# STATE OF VERMONT AGENCY OF TRANSPORTATION

## PROPOSED IMPROVEMENT TOWNS OF TROY AND NEWPORT COUNTY OF ORLEANS VT ROUTE 105

RECORD PLANS	
CONTRACTOR:	PIKE INDUSTRIES, INC. - BERLIN, VT
RESIDENT ENGINEER:	KEVIN MCCLURE
CONSTRUCTION BEGAN:	APRIL 19, 2010
CONSTRUCTION COMPLETE:	OCTOBER 11, 2010
RECORD PLANS BY:	KEVIN MCCLURE & C. PIERCE
I HEREBY CERTIFY THAT ALL THE CONSTRUCTION REQUIRED BY THIS SET OF DRAWINGS HAS BEEN ACCOMPLISHED AS INDICATED HEREIN.	
BY <u>Kevin McClure</u>	RESIDENT ENGINEER
DATE <u>9-1-11</u>	
NOTE: Any further information concerning final quantities, amounts or other details relative to this project may be found at Central Files in the electronic archives.

DIRECTOR OF PROGRAM DEVELOPMENT	
APPROVED <u>[Signature]</u>	DATE <u>7-20-09</u>
PROJECT MANAGER : TED DOMEY	
PROJECT NAME : TROY-NEWPORT	
PROJECT NUMBER : STP 2613(1)	
SHEET 1 OF 31 SHEETS

PROJECT LAYOUT SHEET 8

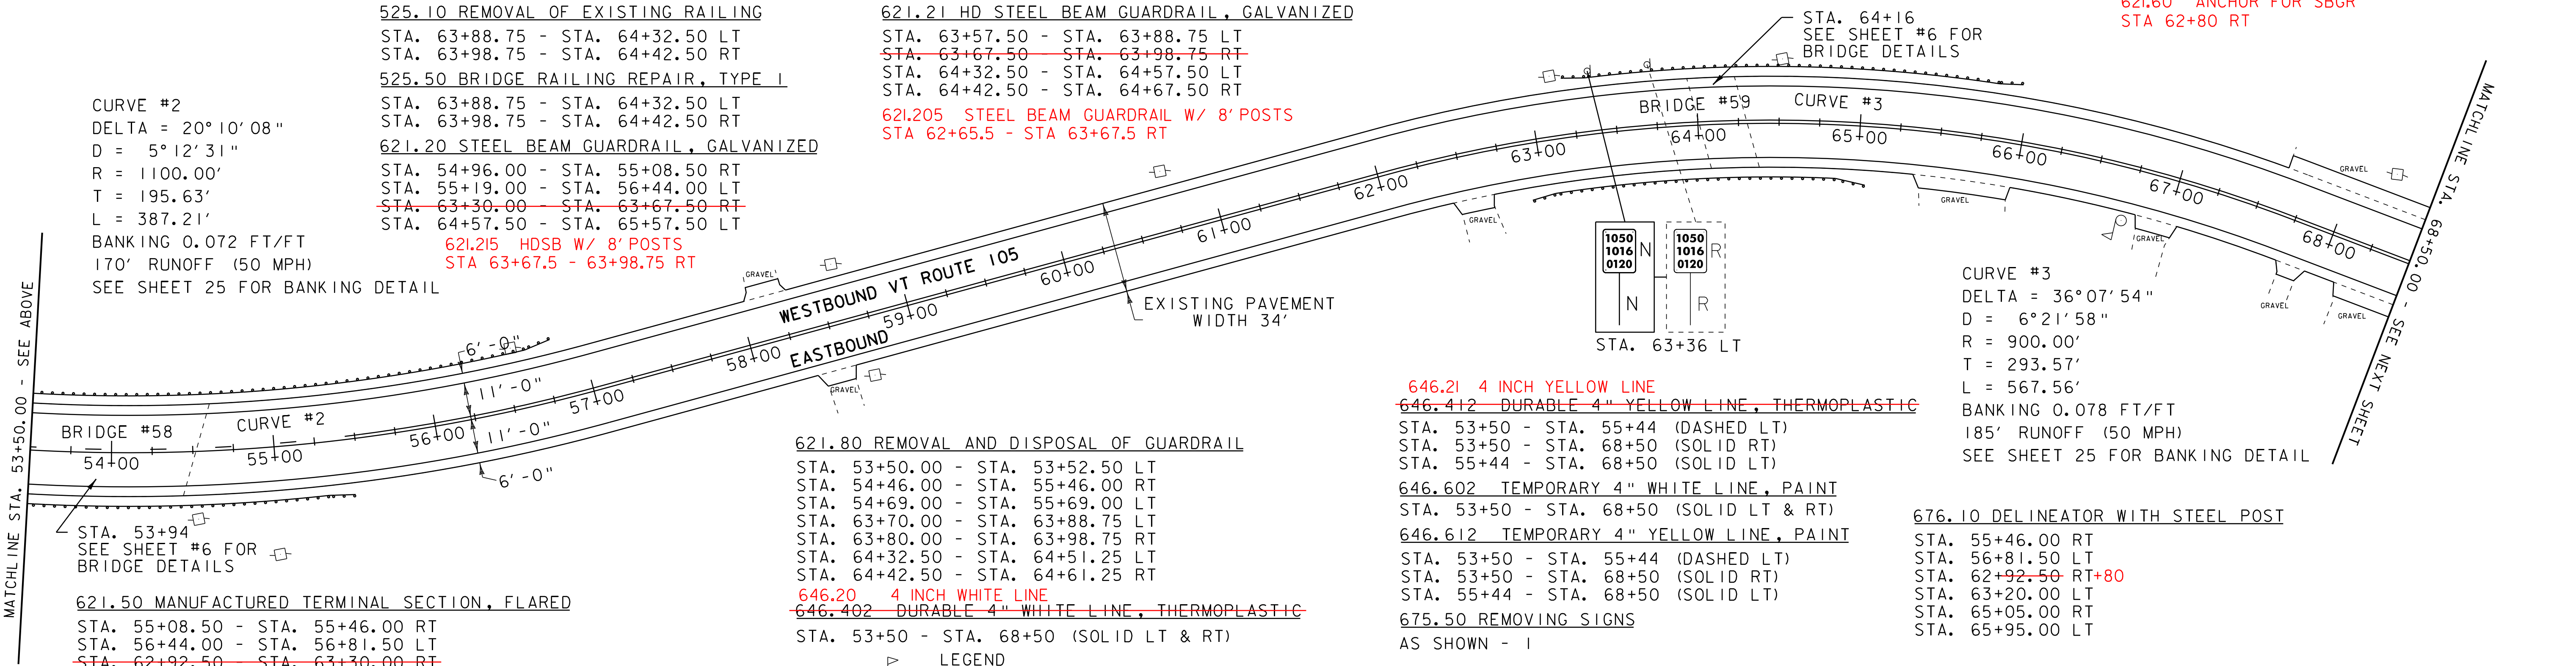
621.21 HD STEEL BEAM GUARDRAIL, GALVANIZED  
 STA. 63+57.50 - STA. 63+88.75 LT  
~~STA. 63+67.50 - STA. 63+98.75 RT~~  
 STA. 64+32.50 - STA. 64+57.50 LT  
 STA. 64+42.50 - STA. 64+67.50 RT  
 621.205 STEEL BEAM GUARDRAIL W/ 8' POSTS  
 STA 62+65.5 - STA 63+67.5 RT

**PROJECT LAYOUT SHEET 9**

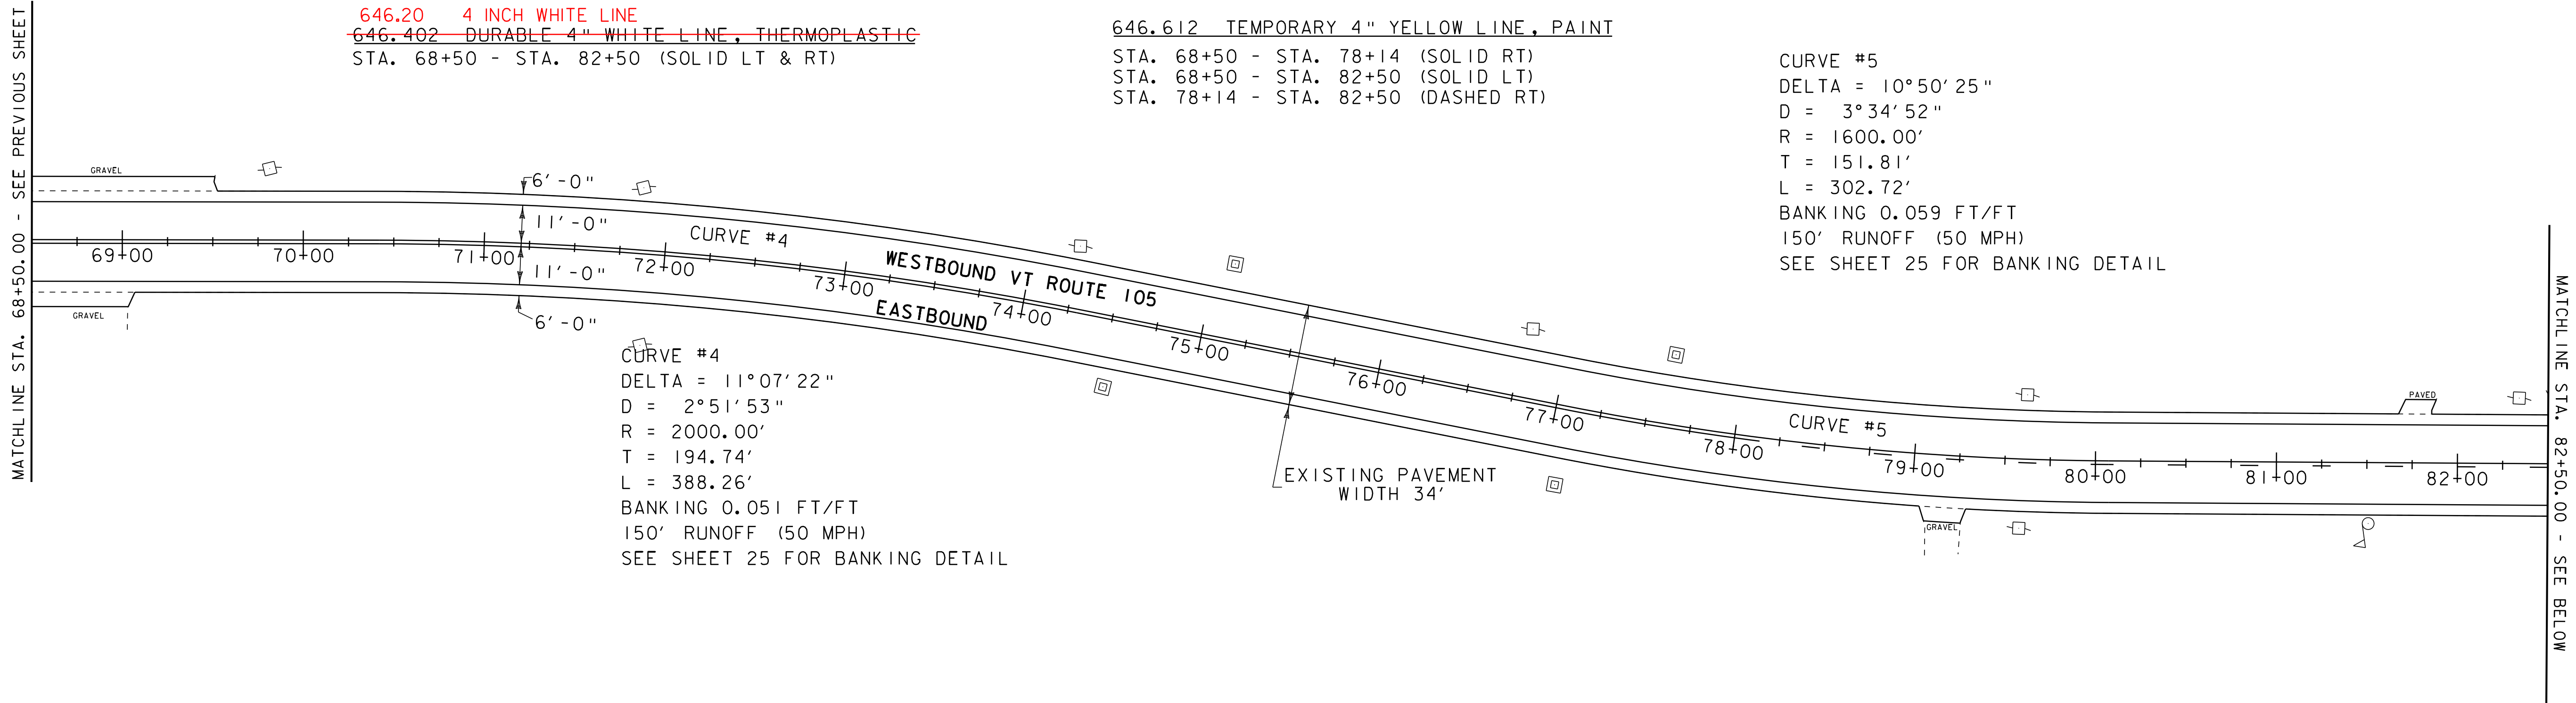
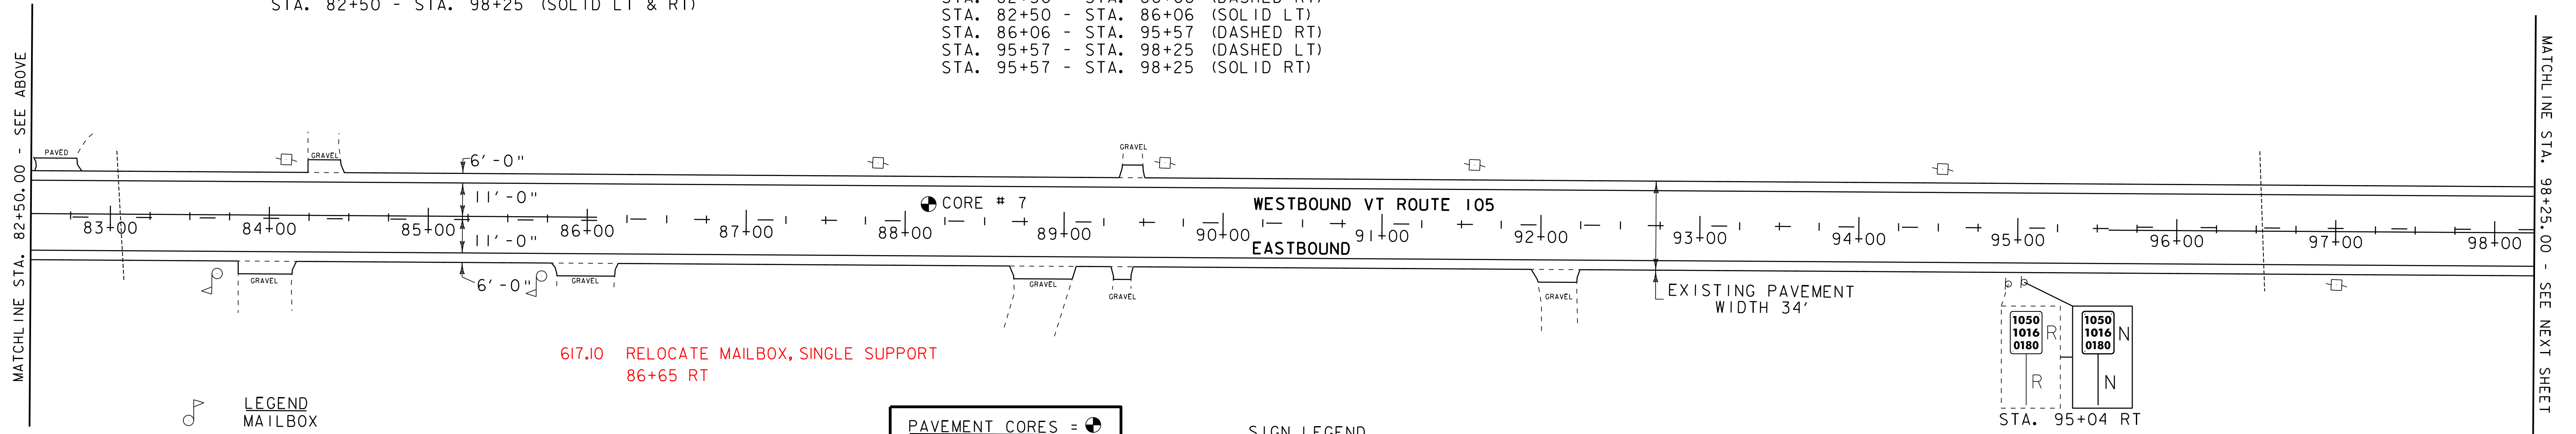
~~646.412 DURABLE 4" YELLOW LINE, THERMOPLASTIC~~  
 646.21 4 INCH YELLOW LINE  
 STA. 68+50 - STA. 78+14 (SOLID RT)  
 STA. 68+50 - STA. 82+50 (SOLID LT)  
 STA. 78+14 - STA. 82+50 (DASHED RT)

~~646.402 DURABLE 4" WHITE LINE, THERMOPLASTIC~~  
 646.20 4 INCH WHITE LINE  
 STA. 82+50 - STA. 98+25 (SOLID LT & RT)
